Service Bulletin

Bulletin No.: PIT6493B

PRELIMINARY INFORMATION

Subject: Wind Noise From Driver Front Door

7103883

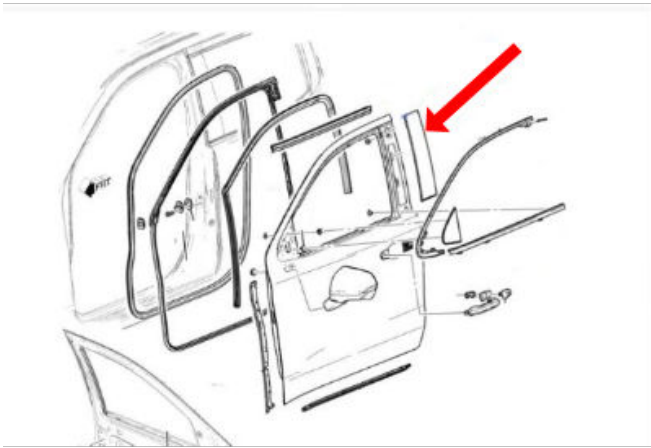
1. Remove Front Side Door Window Frame Rear Applique (example doc ID for Suburban 6748244)

Note: On some models the belt molding is a one time use part which will need to be replaced.

7111709

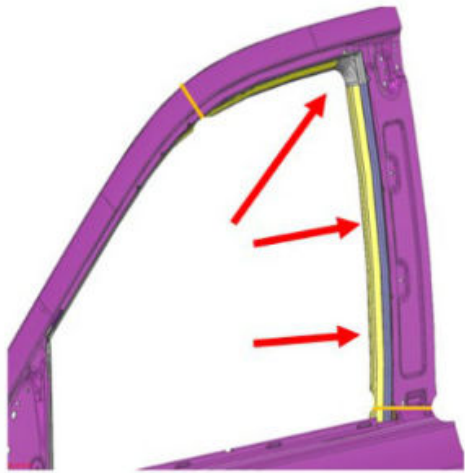
2. Ensure that the Front Side Door Window Weatherstrip is fully seated into the door metal run channel and that the rear upper molded-in alignment pin is fully seated into the square hole at the rear of the upper door opening (as shown below.) If the rear upper molded-in alignment pin is not seated in the hole or the weatherstrip is not fully seated in the channel, it will push the window weatherstrip forward creating a large gap between the weatherstrip and applique.

If weatherstrip or rear upper molded-in alignment pin is not fully seated, remove and reinstall the window weatherstrip

Reinstall the weatherstrip making sure the rear upper molded-in alignment pin is fully seated in the square hole in the door and that the weatherstrip is fully seated into the door metal run channel.

To seat the pin correctly, push the molded portion of the seal upward as far as possible, then rearward.
